GUNNISON STREET

IL 43 TO NAGLE AVE

NEWSLETTER

Public Meeting Summary

Vehicle Capacity Concerns

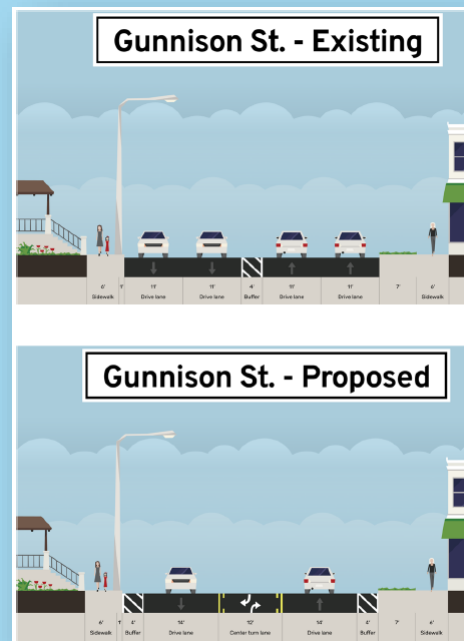
The Department received several comments regarding vehicles backing up due to the loss of a travel lane. Gunnison St is classified as a minor arterial. In general, 4-lane highways typically accommodate average daily traffic ranges of 18,000 to 36,000 vehicles per day while 3-lane highways typically effectively accommodate traffic with 8,500 to 17,500 vehicles per day. The existing 4 lane corridor of Gunnison St has an average daily traffic of 14,500 vehicles per day; **well under the capacity needs of the current roadway** configuration which leads vehicles to exceed posted speed limits and higher incidence of crashes.

Bus Turnouts and Refuge Islands

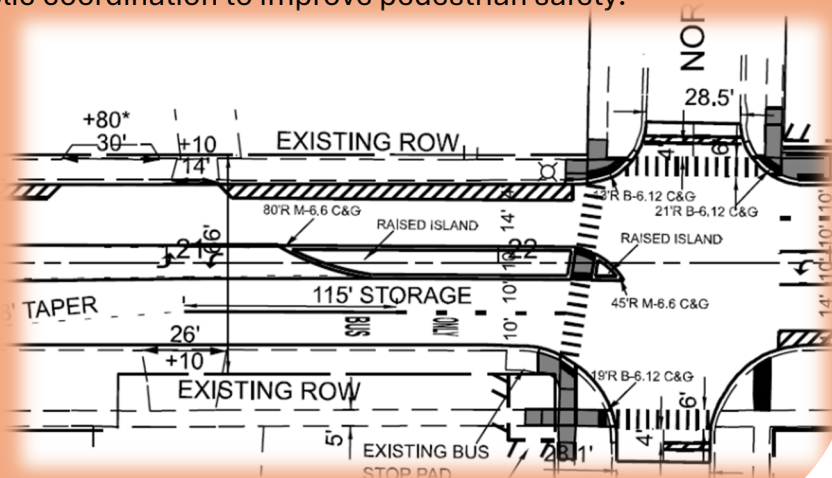
The Department received concerns over increased likelihood of rear-impact collisions at bus stops and requests for bus turnouts. Thru extensive coordination with the Chicago Transit Authority (CTA) the Department was able to reconfigure the roadway space to allow bus only turnouts at the various transit stops along the Gunnison St corridor. Refuge islands were considered as part of the proposed improvements, but several were in conflict with vehicular turning movements at the intersections, creating safety issues for both vehicular traffic and pedestrians at the refuge islands. However, the Department was able to incorporate refuge islands at two intersections: Sayre/Nordica Avenue and Oak Park Avenue. Some stops along the corridor that created safety crossing issues were removed and consolidated as part of the CTA and public coordination to improve pedestrian safety.

Improved CTA stops:

- Mont Clare Ave
- Nordica Ave
- New England Ave
- Oak Park Ave,
- Natoma Ave
- Nagle Ave.

Removed CTA stops:

- Neenah Ave
- Rutherford Ave
